STAFF RECOMMENDATION

1830 5th Ave N
February 17, 2021

Application: New Construction—Infill and Outbuildings; Setback Determination

Description of Project: Application is to construct duplex infill and outbuildings. The project includes requests to reduce the street setback on Coffee Street from ten feet (10') to nine feet (9') for the infill and to five feet, six inches (5'-6") for an outbuilding.

Figure 1. 1830 5th Avenue N.

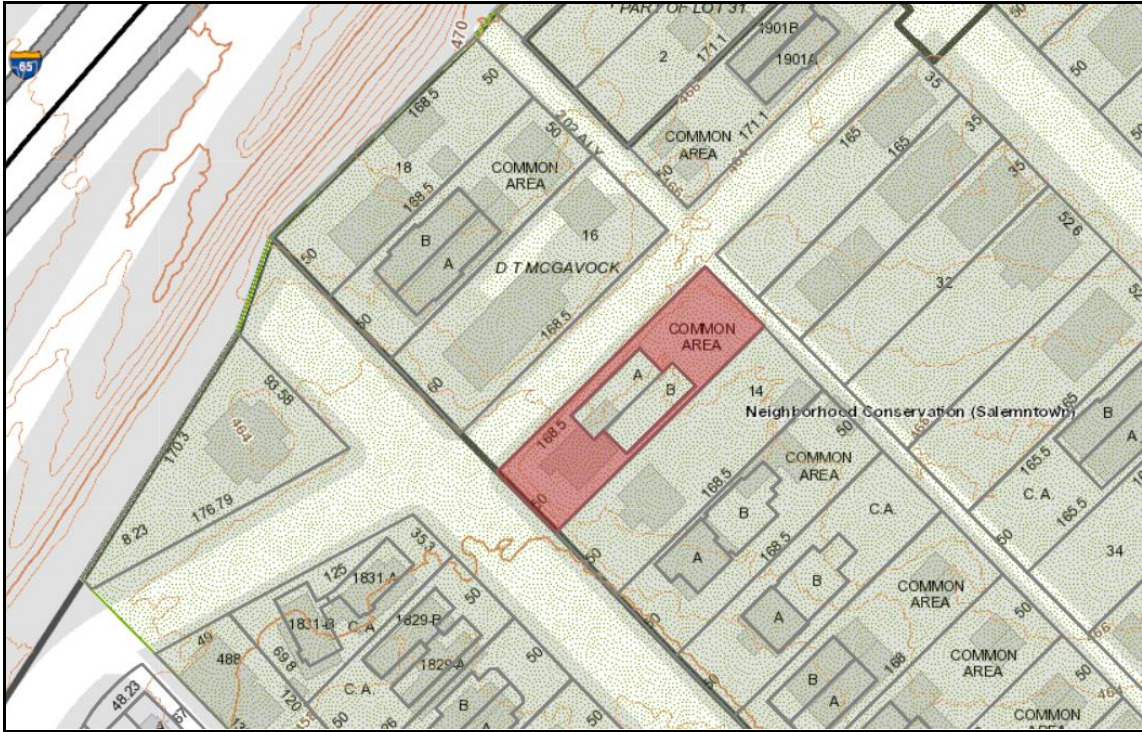
Background: The house at 1830 5th Avenue North was constructed c. 1925 and contributes to the historic character of the Salemtown neighborhood (Figure 1). In January 2021, the Commission found that the building met the criteria for economic hardship and approved the building's demolition.

SITE PLAN (1)

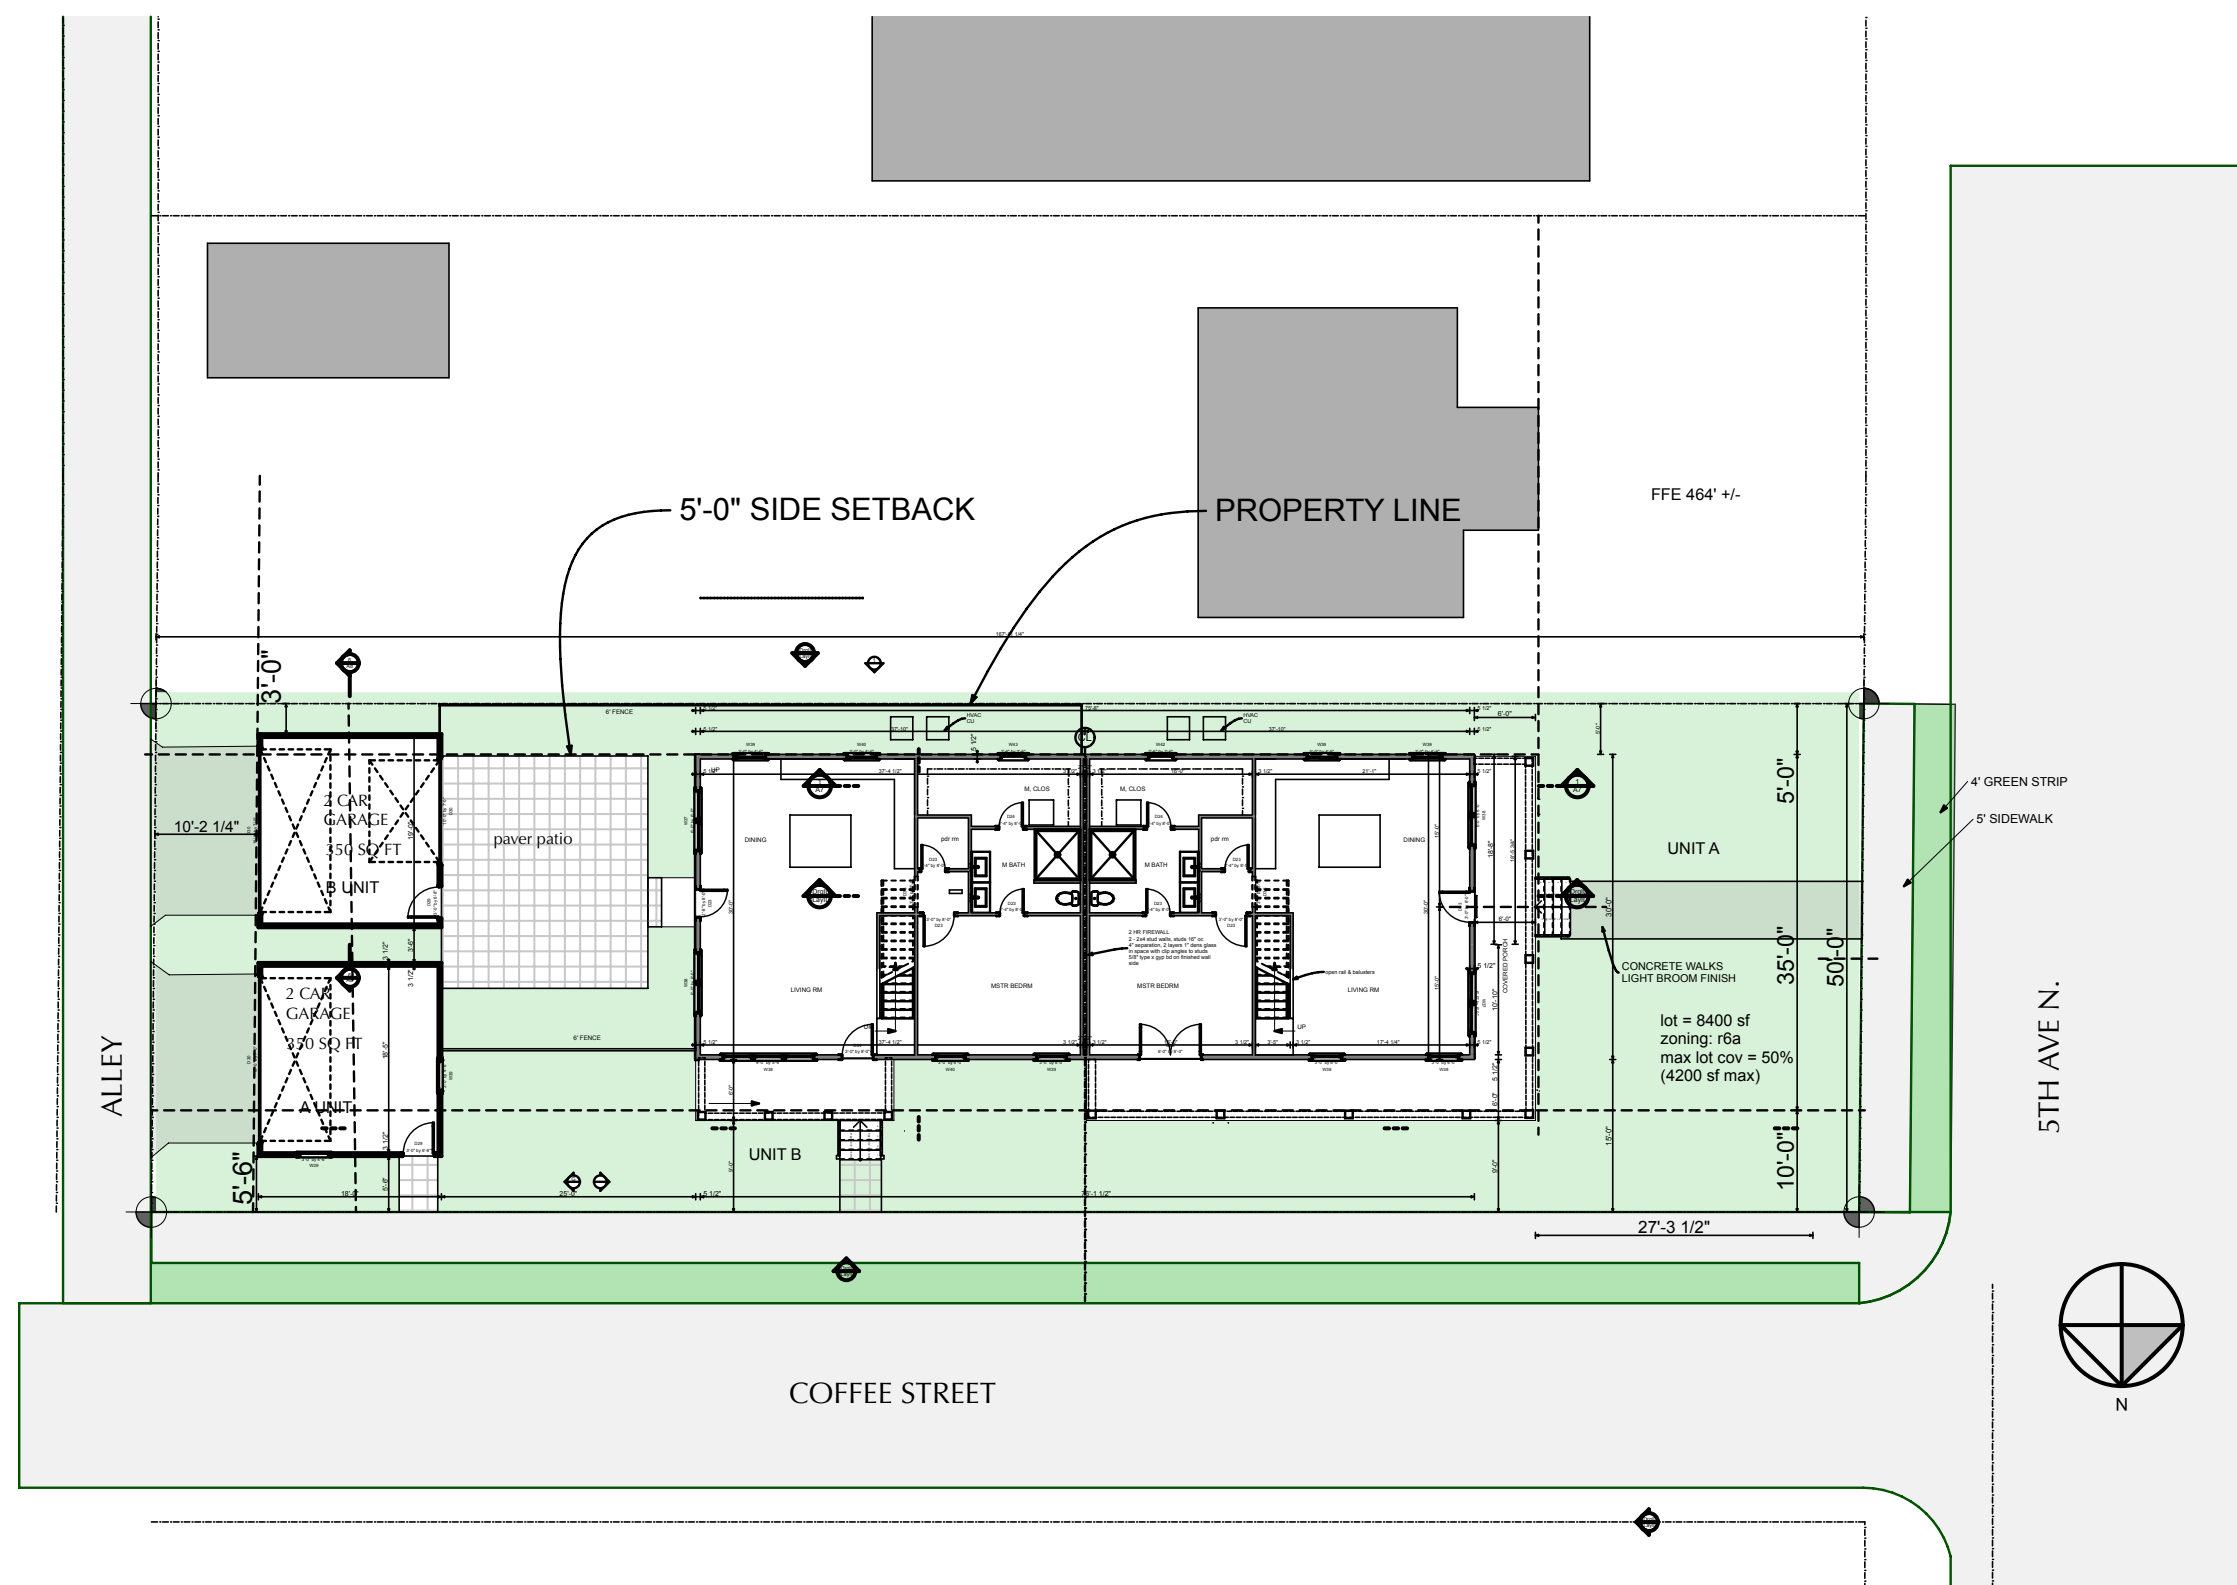
Setback & Rhythm of Spacing: The primary building is centered on the lot and will have a front setback of approximately thirty-three feet, six inches (33'-6"), which is similar to the house to the right of the site and compatible with the historic house at 1824 5th Avenue N. The infill will be five feet (5') from the right-side property line,

approximately fifty-six feet (56') from the rear property line, and twenty-six feet (26') from the outbuildings, meeting the zoning requirements for setbacks. However, the infill requires a setback determination for its side setback from Coffee Street. Base zoning requires a ten-foot (10') street setback from Coffee Street for corner lots. The bulk of the infill will meet the ten-foot (10') setback, but the wraparound and side porches intrude one foot (1') into the setback. Staff finds the proposed setback for the Coffee Street property line to be appropriate for several reasons. The main portion of the house will meet the side setbacks, and it is only open porch elements that intrude on the setback. The porches help to break up the Coffee Street façade and add architectural interest to this highly visible part of the infill. Moreover, an analysis of the corner lots nearby show that the historic structures, including the two-story structures at 1900 and 1901 4th Avenue North, are situated less than ten feet (10') from the Coffee Street property line. For these reasons, staff finds that the proposed reduced Coffee Street property line setback meets the design guidelines.

Staff finds that the project meets Section II.B.1.c of the design guidelines.

GARAGE (1)

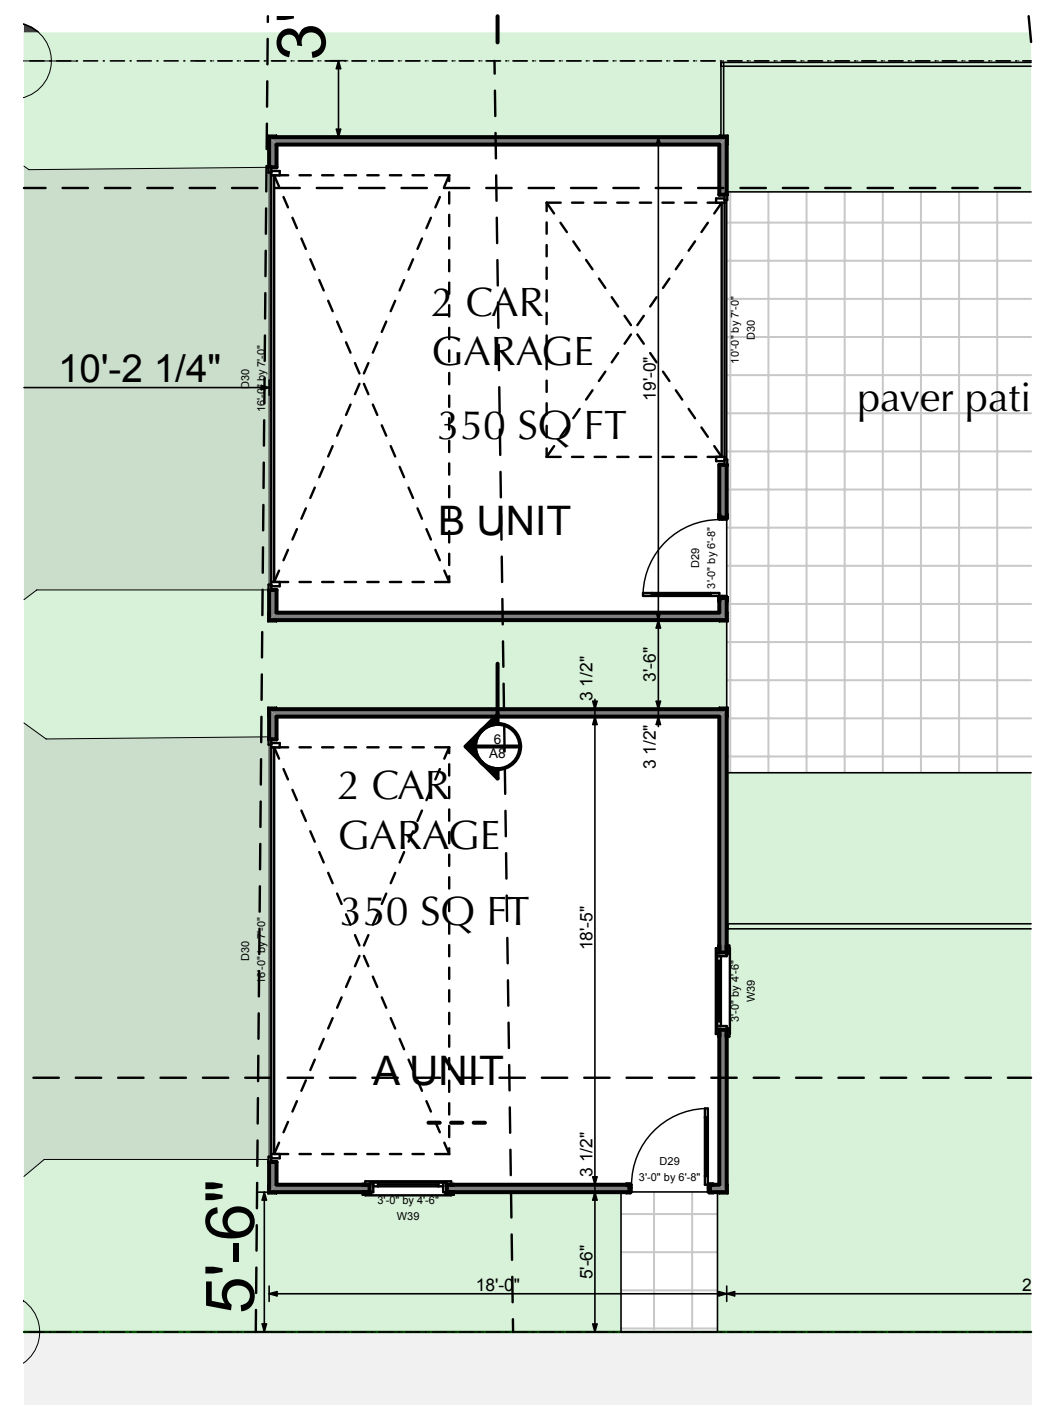
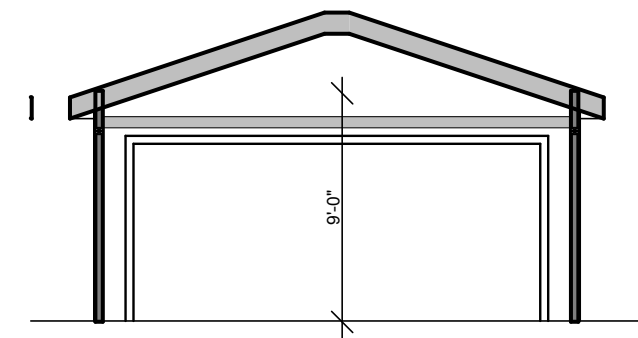
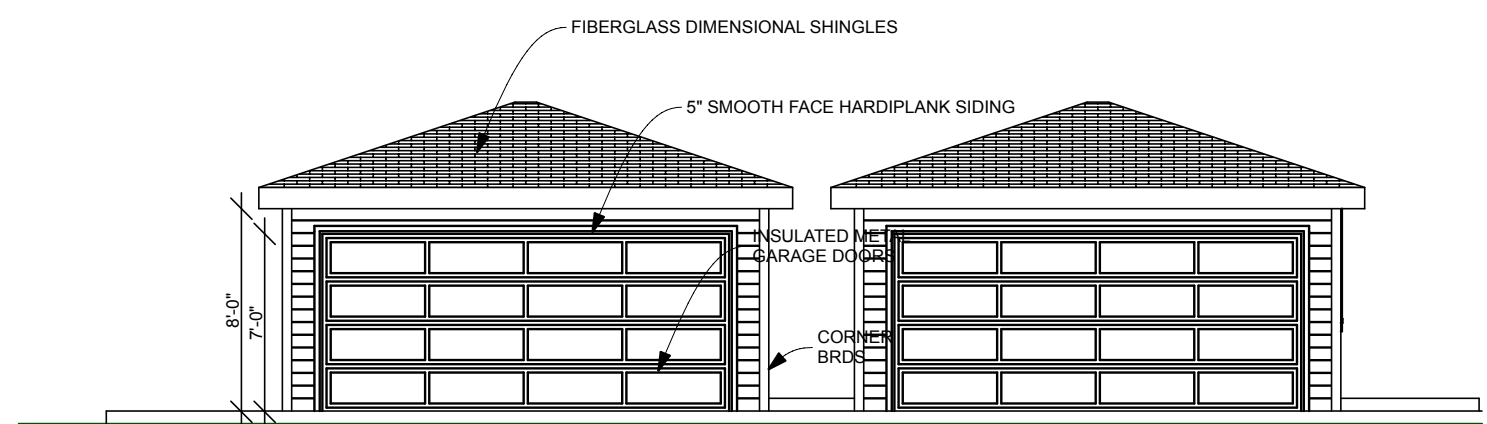
* The proposed carport requires a setback determination from the ten-foot (10') street setback along Coffee Street. The applicant is proposing to locate the outbuilding five feet, six inches (5'6") from the Coffee Street property line. Staff finds the proposed setback to be appropriate because historically outbuildings sat close to side property lines and it is similar to what the Commission approved at 1901 4th Avenue North for an outbuilding. Staff finds that the proposed setbacks are appropriate to the Salemtown Neighborhood Conservation Zoning Overlay.

The outbuildings are single-story, which is appropriate behind a two-story house. The outbuildings has a utilitarian design that is appropriate for an accessory structure. Staff finds that the proposed design meets Section III.H.2 of the design guidelines.

Staff finds that the propose outbuilding’s height, scale, placement, setbacks, materials, and design meet Section III.H of the design guidelines.
